Evaluation of iSpin anemometry uncertainty analysis

February 2017
ECN-E--16-065

This project is carried out on the authority of ROMO Wind A/S, Olof Palmes Allé 47, 8200 Aarhus, Denmark. ECN project number 5.4479.

Figure 2: iSpin sensor

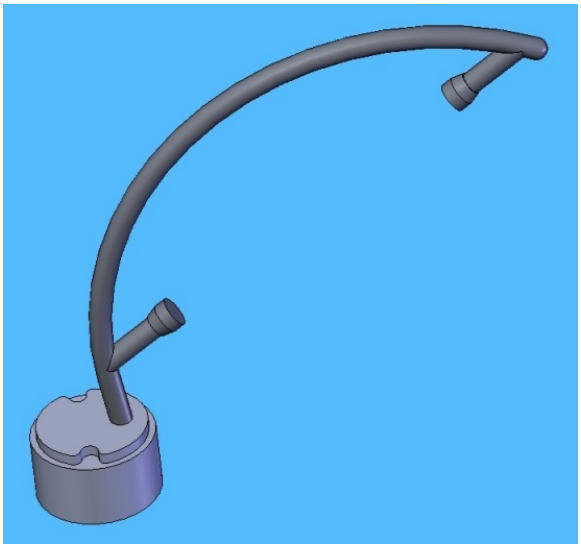
[2] This is the angle between the line connecting the sonic sensor heads and the mounting plate. See figure 2. This angle is typically 35°.

Besides the mounting position errors, sensor mounting angle errors are described in two directions. The third possible rotation is not mentioned; a rotation of the sensor base around an axis that is tangent to the spinner surface and in the same plane as the rotor shaft. Admittedly, this rotation would have only a minor effect on the wind speed - apart from the inherent rotation of the accelerometer - compared to the other two directions.
